Contract #: 04-0120F4  
 Cty: SF/ALA Rte: 80 PM: 13.2/13.9  
 File #: 69.25B

## QUALITY ASSURANCE -- NON-CONFORMANCE REPORT

**Report No:** NCR-000855

**Reference Description:** East and North Shaft at 119m: Skin E - Fit Lug removal without Engineer's approval

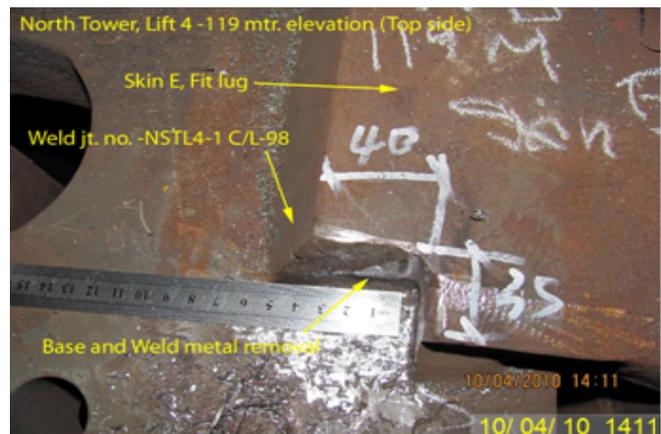
-Approx. 55 mm length, 25 mm width, weld metal and base metal removal observed in Skin E, fit lug weld without Engineer's approval.

-The fit lug found in East Tower, Lift 4- 119m top diaphragm.

-The weld joint no. of the fit lug weld found to be ESTL4-2 C/L-115.

Contractor will grind the cut corner as per the Designer's requirements. ie. tapering the cut corner and perform MT. Contractor will provide the NDT report to prove the welds are acceptable. Contractor will discuss with the foreman about the issue, and instruct the foreman/ QC notification prior to Engineer is required to any retrofit work being performed.

Contractor ground the cut corner as per Designer's request. The forman/QC was warned and instructed that the Engineer has to be notified, and approval has to be sought prior to any retrofit work.

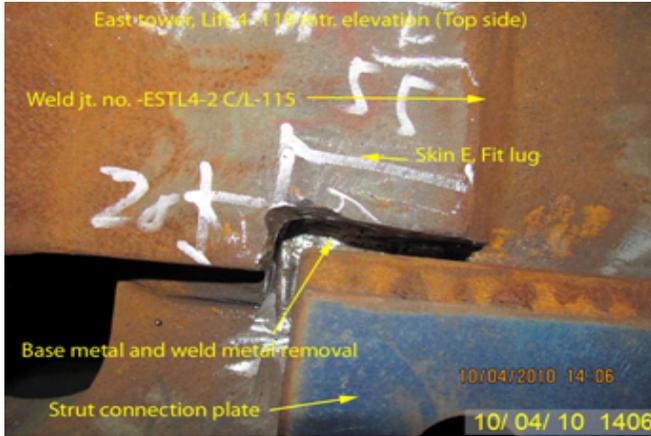
-Approx. 50 mm length, 35 mm width, weld metal and base metal removal observed in Skin E, fit lug weld without engineer's approval.

-The fit lug found in North Tower, Lift 4- 119m top diaphragm.

-The weld joint no. of the fit lug weld found to be NSTL4-1 C/L-98.

This proposed resolution is accepted with action pending. The retrofit work per TC-RFI 0166 for the fit lug on the North Shaft shall be completed and related NDT reports for Weld No. NSTL4-1C/L-98 submitted and reviewed.

**Reference Resolution:** Note that NSTL4-3C/L-98 was incorrectly identified in NCRF ZPMC-0817 as NSTL4-1C/L-98, ZPMC is submitting NDT for the correct weld ID.

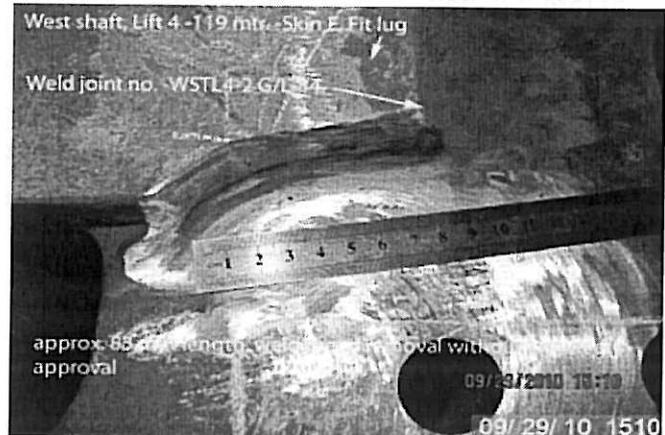
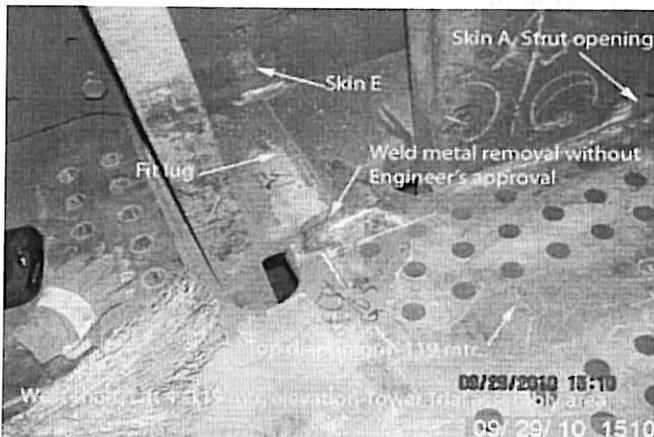
- Approximately 85mm in length, (25mm wide) of Fit Lug that was welded to the top diaphragm. Skin Plate E was removed without engineer approval.

- The Fit lug found in top diaphragm, skin E, Lift 4- 119 mtr, West Tower,
- The Weld removed has the following Weld ID: WSTL4-2 C/L-86.

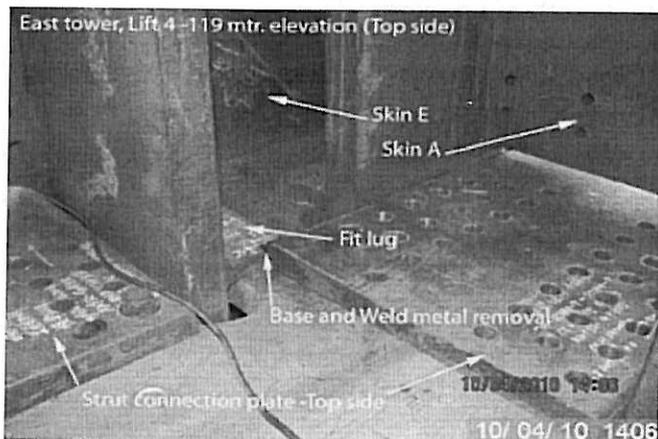
-Approx. 55 mm length, 25 mm width, weld metal and base metal removal observed in Skin E, fit lug weld without Engineer's approval.

-The fit lug found in East Tower, Lift 4- 119m top diaphragm.

-The weld joint no. of the fit lug weld found to be ESTL4-2 C/L-115.

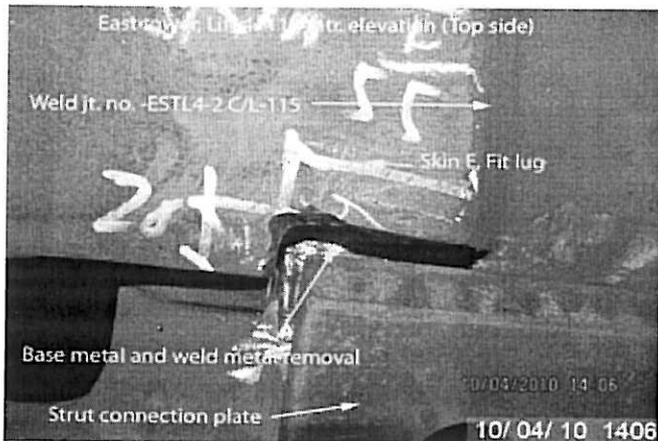
-Approx. 50 mm length, 35 mm width, weld metal and base metal removal observed in Skin E, fit lug weld without engineer's approval.

-The fit lug found in North Tower, Lift 4- 119m top diaphragm.

-The weld joint no. of the fit lug weld found to be NSTL4-1 C/L-98.

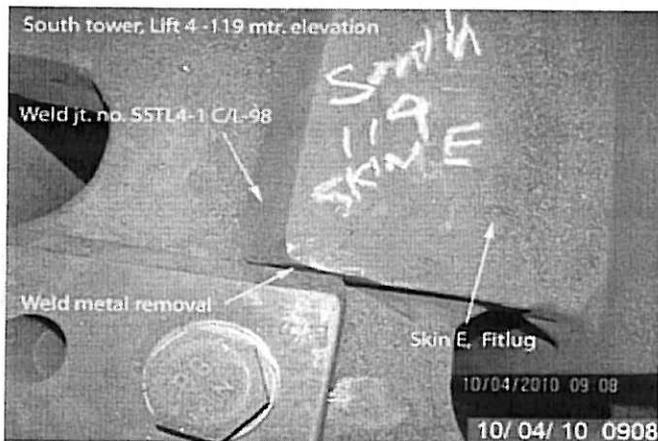
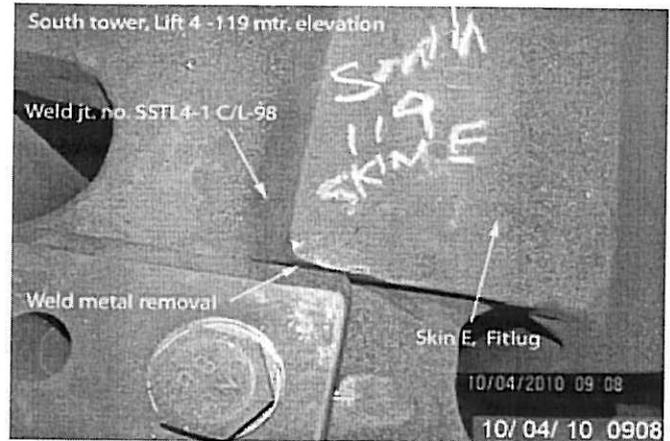
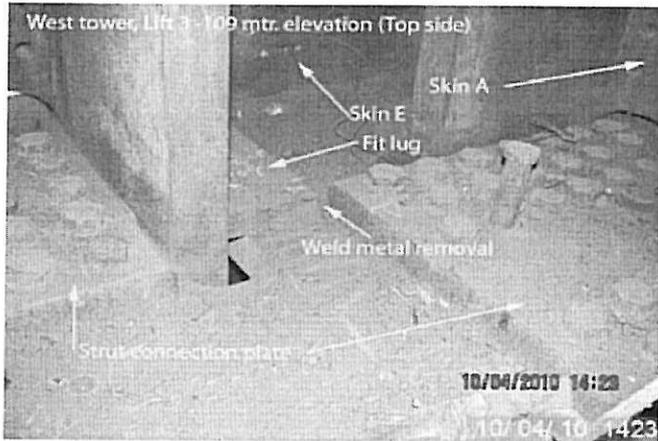
- Approx. 50mm length, weld metal removal observed in Skin E, fit lug weld, without Engineer's approval.
- The fit lug found in West Tower, Lift 3- 109m top diaphragm.
- The weld joint no. of the fit lug weld found to be WSTL3-4 I / K-128.

- Approx. 55mm length, weld metal removal observed in Skin E, fit lug weld, without Engineer's approval.
- The fit lug found in South Tower, Lift 4- 119m top diaphragm.
- The weld joint no. of the fit lug weld found to be SSTL4-1 C/L-98.

This proposed resolution is accepted with action pending. The provided NDT reports do not address the the Lift 4 portion of this NCR. Please provide applicable NDT reports for Weld No. SSTL4-1C/L-98 noted in the NCR.
